# Product Change Notification

## 112344 - 00

**Change Notification #:** 112344 - 00  
**Change Title:** Intel® Server System P4304BTSSFCNR  
PCN 112344-00, Product Design  
Cable and Label Changes  
**Date of Publication:** June 07, 2013

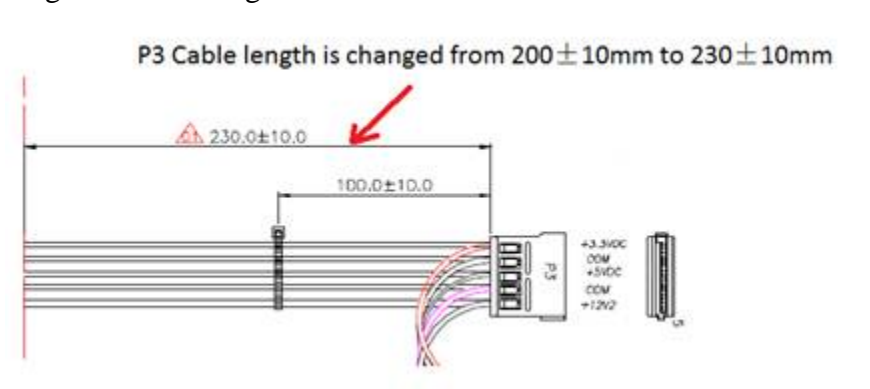
1. Change the cable length of P1 from 170mm to 290mm

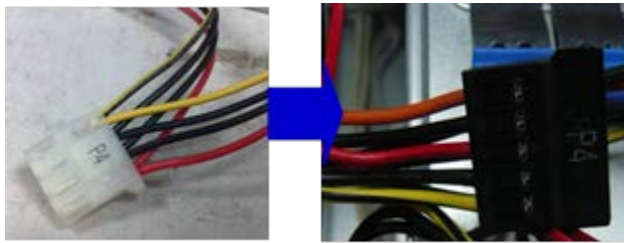
2. Change the cable length of P3 from 200mm to 230mm.
